Overview: Production error; immobilizer wire (orange/black) in pin position #4 instead of pin position #5. Although an effort to correct the issue was made, some quantity of harnesses did get shipped before the issue was spotted. We are advising to inspect the harness BLADE connector before attempting to install the harness and program the module.

Descripción general: El nuevo arnés en T FTI-STP1 requiere modificaciones para su uso en aplicaciones de transmisión automática (AT).

FTI-STP1: Notas de instalación y configuración

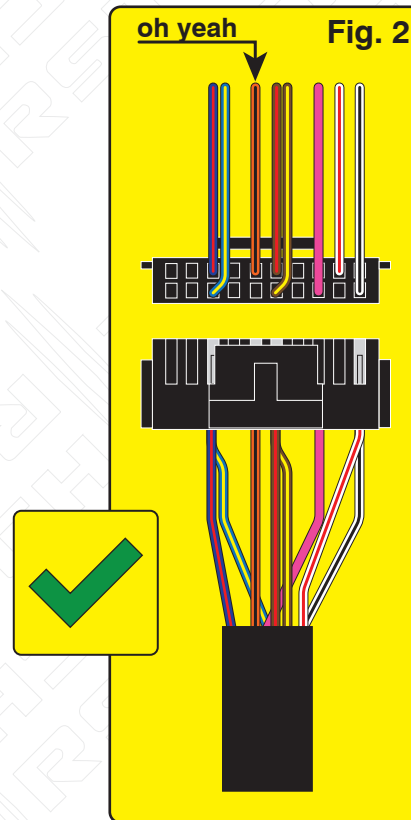
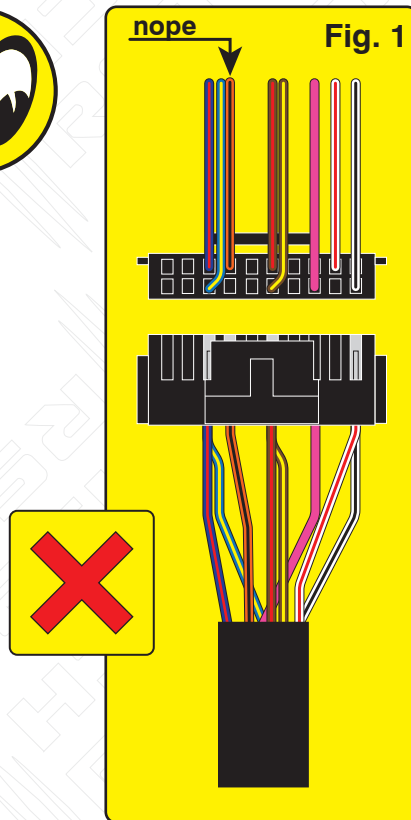
Issue: Module fails to program to vehicle, will not allow the vehicle to be remote started.

Correction: Step 1.) Locate the orange/black wire and confirm whether it is positioned as illustrated in Fig. 1 or Fig. 2. If the wire is as illustrated in Fig.1, proceed with Step 2 through 5 and complete the repair procedure outlined, if the wire is as illustrated in Fig. 2, correction is not necessary, proceed with harness installation and module programming.

Step 2.) Using a pick, lightly depress the catch that secures the terminal in the housing then remove the wire and terminal from the housing.

Step 3.) Using a fine tip razor or utility knife, insert the blade beneath the terminal catch and raise it slightly, so that it can be reused to secure the terminal when reinserted into the BLADE connector housing.

Step 4.) Refer to Fig. 2 for correct position of the orange/black wire (next to brown/red) then reinsert the terminal, pressing lightly until the catch 'snaps' into place, securing the terminal in the connector housing.

Step 5.) The repair is complete, proceed with installation and programming.

MODIFICACIÓN REQUERIDA PARA APLICACIONES DE TRANSMISIÓN AUTOMÁTICA ÚNICAMENTE

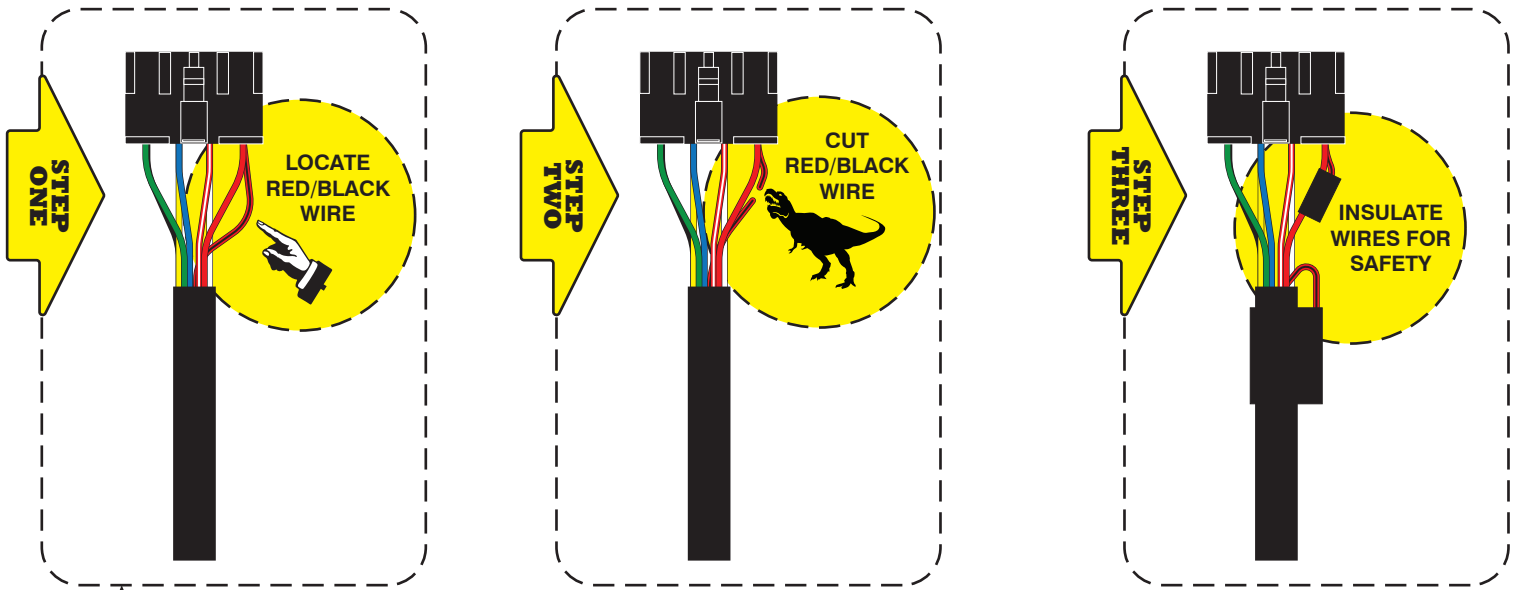
Problema: El arnés en T FTI-STP1 ha sido diseñado para ser compatible con AT (transmisión automática) y MT (transmisión manual), pero debido a una supervisión de la producción, el mecanismo de selección se estableció por defecto en el modo MT.

El uso de un arnés configurado para una aplicación MT, en un vehículo equipado con AT, podría provocar daños en el módulo del vehículo. Se recomienda que el arnés vuelva al modo AT antes de instalarlo en vehículos equipados con transmisión automática.

Corrección: Localice el cable rojo/negro (+ embrague) provisto en el conector CN1 del conjunto del arnés principal. Corte el cable rojo / negro, ya sea al ras del conector CN1 o dejando suficiente cable expuesto para que pueda aislar y asegure los extremos del alambre que quedan después del corte. Aísle cada uno de los extremos restantes del cable rojo/negro y asegúrelos para evitar cualquier posibilidad de cortocircuito.
